EDMS NO. <b>1973905</b>	REV. <b>0.1</b>	VALIDITY <b>DRAFT</b>
----------------------------	--------------------	--------------------------

REFERENCE  
**LHC-TCAP-EC-0001**

## ENGINEERING CHANGE REQUEST

# Installation of New Passive Absorbers (TCAPM) for Warm Magnet Protection in IR7

Figure 1 — Illustrative view of the present (top) and post-LS2 (bottom) layouts of the IR7 Q5 [2,3]. The new TCAPM is represented by the brown box immediately upstream of the MQWA.D5, installed in the space freed by the removal of the MQWA.E5. A specular layout is planned for beam 2.

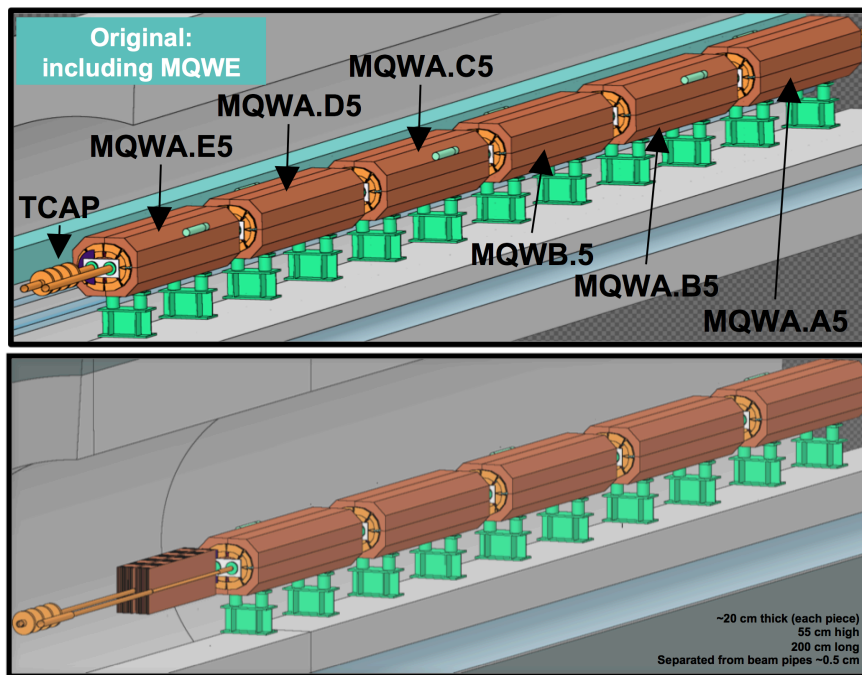
The requirements and a detailed performance assessment of possible new layouts were discussed in various Collimation Upgrade Specification meetings – see the presentations by C. Bahamonde in [2,3,4,5,6]. Figure 1 shows in an illustrative sketch, taken from the FLUKA geometry used in simulations, the present layout (top view) and the modified one (bottom view) [2,3]. The latest design was reviewed and endorsed in [6a].

The present passive collimator TCAP (installed upstream of the present MQWA.E5, see Fig. 1) will remain in place and the new passive absorber TCAPM will be added. The latter is outside the vacuum, contrary to the existing passive absorbers. The same elliptical chambers as the present MQW one will be used in this area.

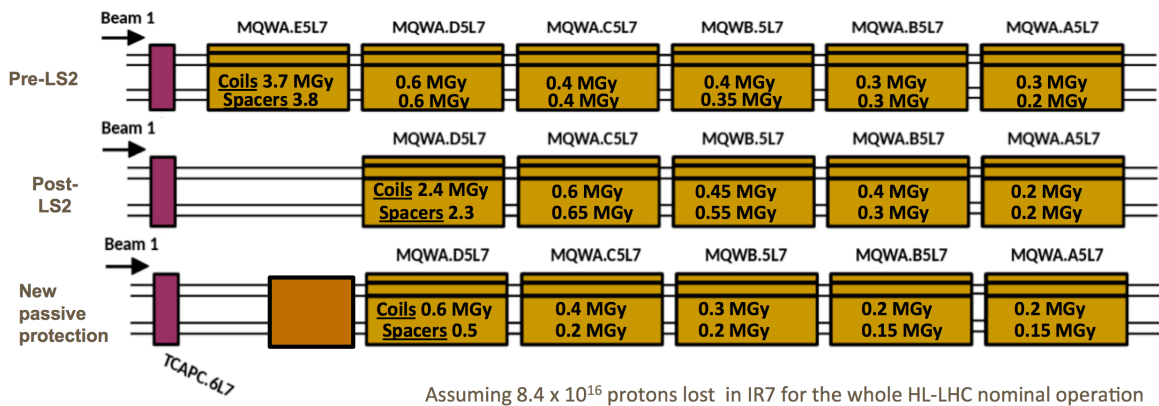
The computed doses in all modules of the Q5 magnets for beam 1, estimated for the whole lifetime of the HL-LHC project [7], are illustrated in Figure 2 for three different layouts [2,3]:

- Present layout (top graph);
- Hypothetical layout without collimation upgrade after magnet removal (middle);
- Proposed post-LS2 layout (bottom) with TCAPM.

Dose values are estimated both for the coil and for the spacers [1]. Note that for all cases, the present TCAPC.6L7.B1 collimator remains at the same location, as this was found to produce good performance. This also avoids intervening on a radioactive collimator. It is clear that without an improvement of the passive collimation layout (middle plot), doses on the downstream MQWs would be much higher than in the present layout. In particular, the dose on the coil spacers [1] of the most exposed magnet would be about a factor 4 larger. The proposed solution with TCAPM (bottom line) described in detail in the next section, solves this issue and brings the doses to an acceptable level.

Figure 3 — Overall design of the TCAPM. Lengths are given in mm. Courtesy of L. Gentini [8].

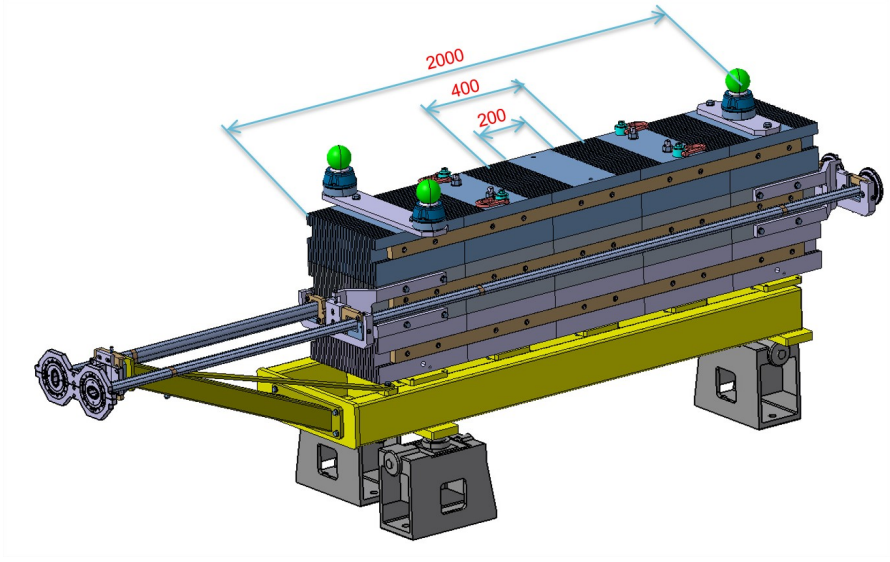
The new absorber's design [8] is shown in Figure 3. More details can be found in:

A new support that will be installed under the vacuum chamber will house a modular structure made of steel blocks, assembled together to fill a volume that ensures adequate shielding of the downstream magnet. The supporting structure consists thereby of a girder (see figure 4) resting on the reused magnet support feet provided by TE-MS. The absorbing part consists of

Figure 4 — The three assembly blocks of the TCAPM. Courtesy of L. Gentini [8].

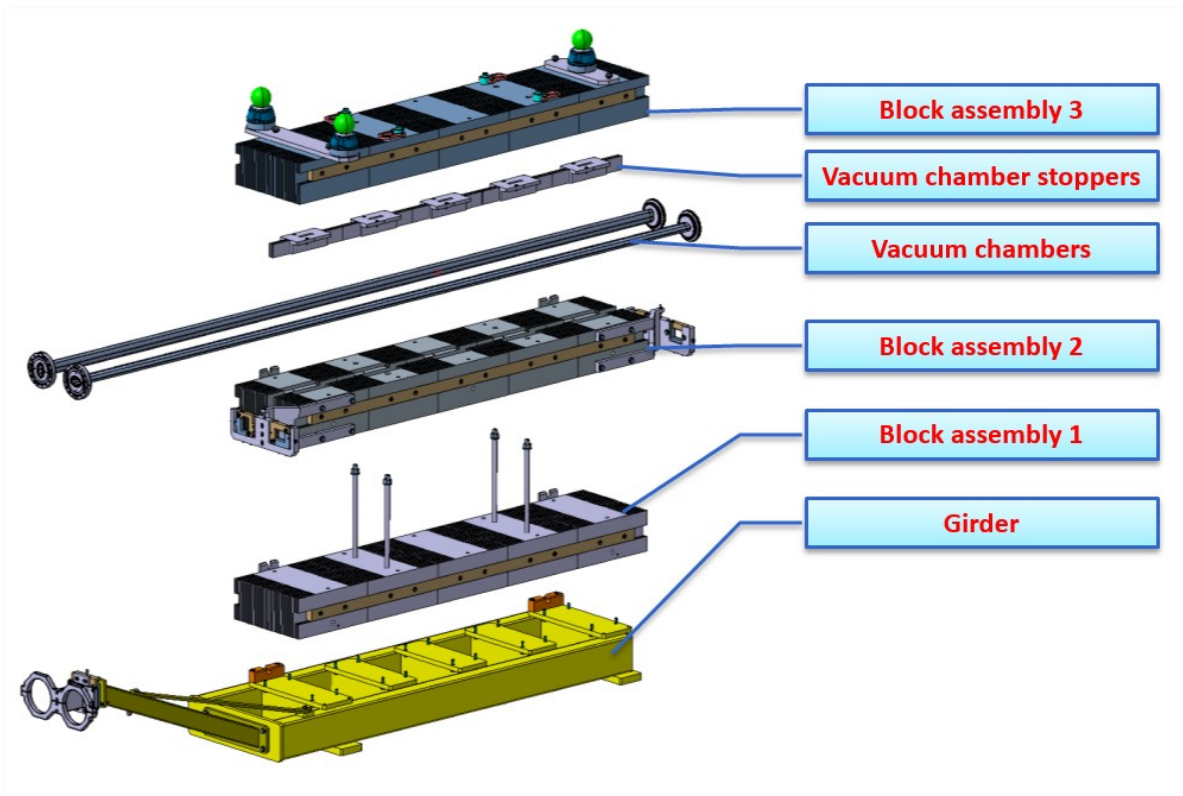
three block assemblies shown in Figure 4. The assemblies 1, 2 and 3 weight respectively 781 Kg, 756 Kg and 779 Kg, for a total of about 2590 kg with the support. The TCAPM transverse cross section is shown in Figure 5. The absorber assemblies are mounted around the existing elliptical beam pipes in a way that leaves minimum empty spaces. The integration layout is shown in Figure 6. The longitudinal central positions of the new passive absorbers are 19852.4064 m for B1 and 20135.9184 m for B2.
